**Proposal for amendments to ECE/TRANS/WP.29/GRPE/2016/3
(Consolidated version)**

This document shows the amendments to ECE/TRANS/WP.29/GRPE/2016/3 proposed in GRPE-72-09 as a consolidated version. Modifications to ECE/TRANS/WP.29/GRPE/2016/3 are marked in track changes.

Draft global technical regulation on Worldwide harmonized Light vehicle Test Procedures (WLTP)

Figure A1/14

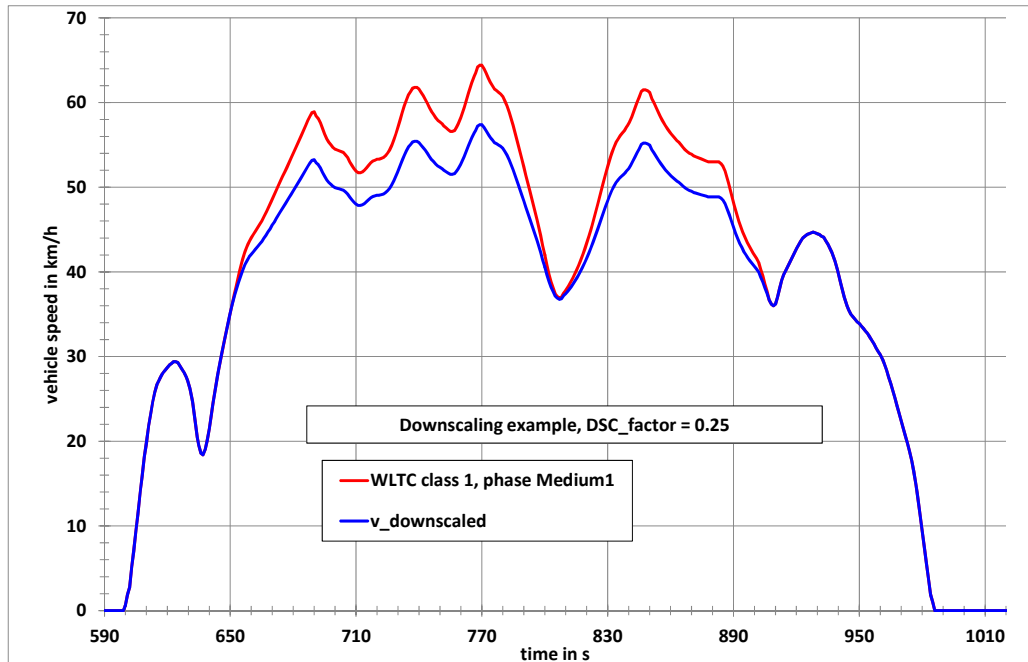
Figure A1/14 shows ~~an example for~~ a downscaled medium speed phase of the Class 1 WLTC as an example.
